**HISTORIC LANDMARK COMMISSION**  
**DEMOLITION AND RELOCATION PERMITS**  
**JUNE 28, 2021**  
**GF-2021-085651; DA-2021-094730**  
**AUSTIN CENTRAL FIRE STATION #1**  
**401 E. 5<sup>TH</sup> ST.**

## **PROPOSAL**

Construct an addition to a 1938 fire station, which is listed in the National Register of Historic Places; and perform additional repairs and modifications to accommodate ongoing use.

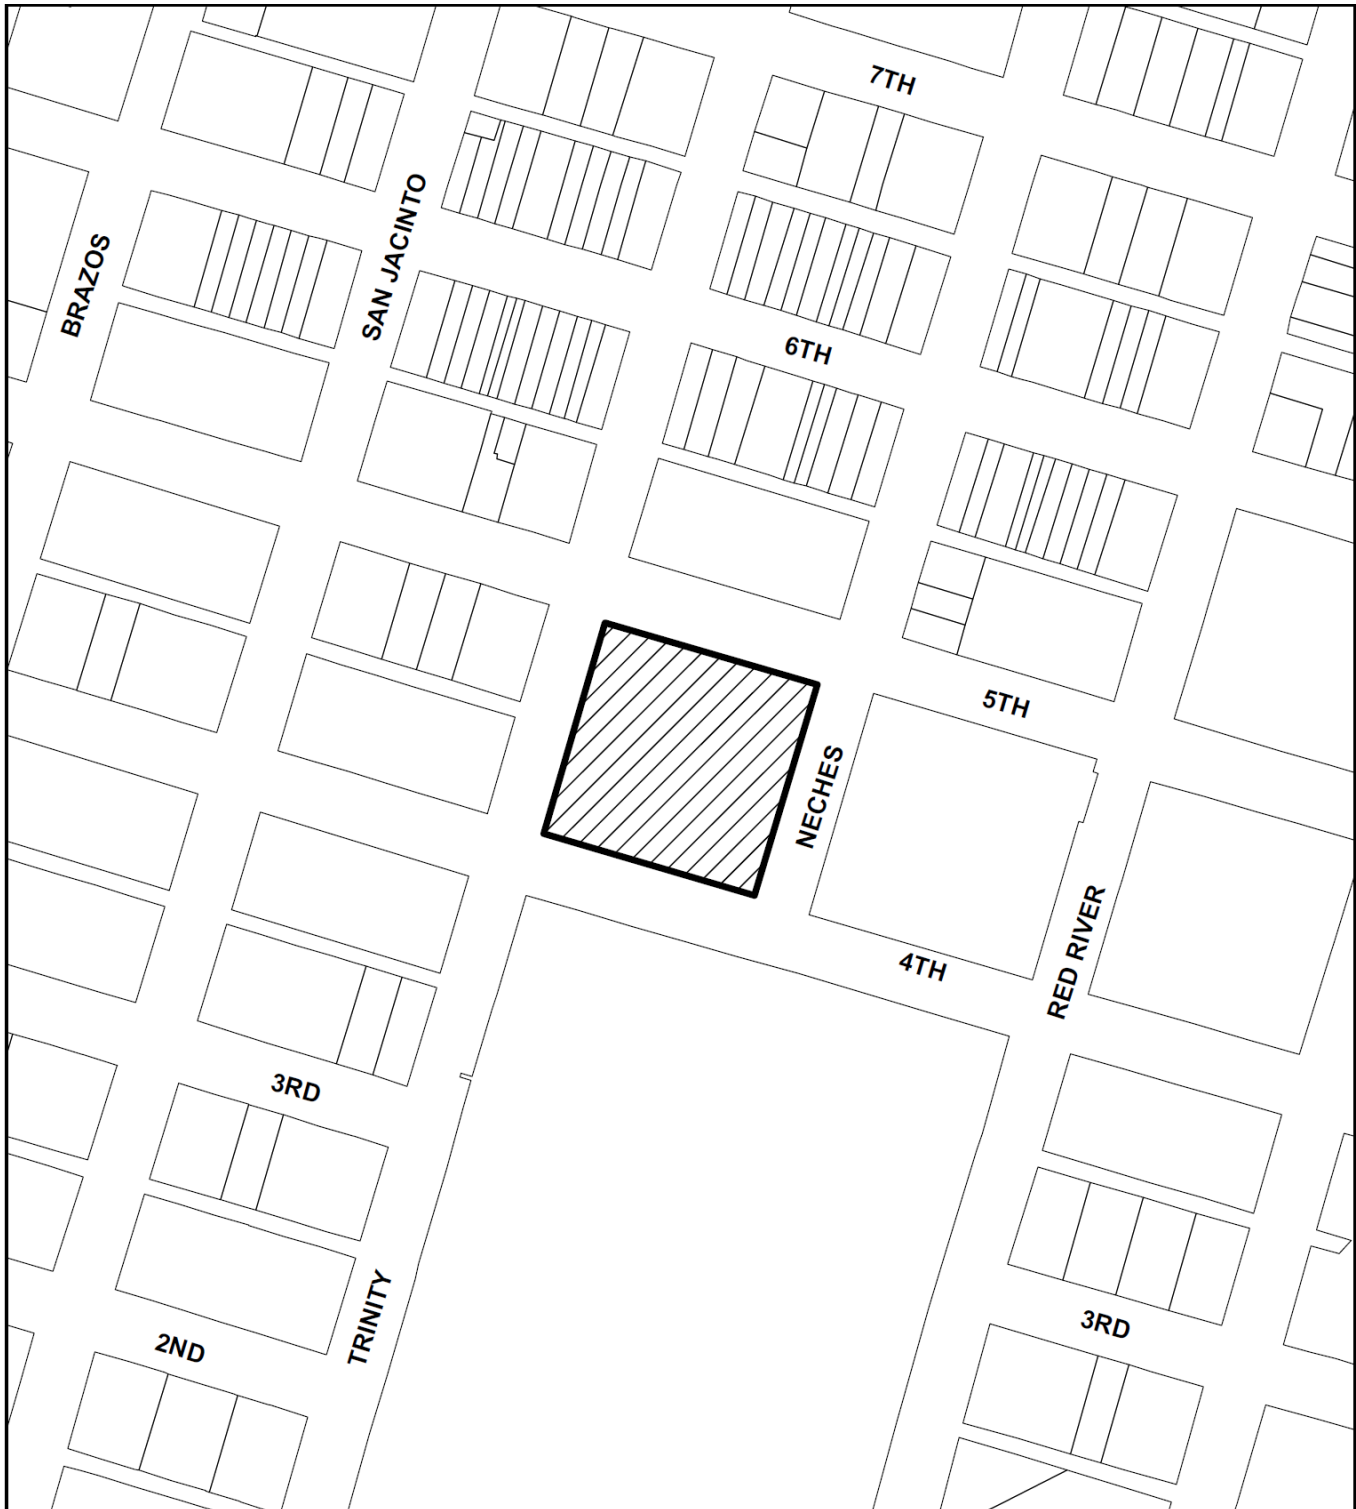
The applicant provided a briefing to the Commission on December 14, 2020. Commissioners acknowledged that an expansion of the vehicle bay height is necessary programmatically but recommended looking at a band or other articulation at the top of the enlarged overhead doors to recapture the effect of the brick patterning.

The architect has looked into this recommendation and does not feel that a decorative garage door is an appropriate substitute for the removed fabric. Although this loss is clear, the preference is to maintain the clean lines of the original design.
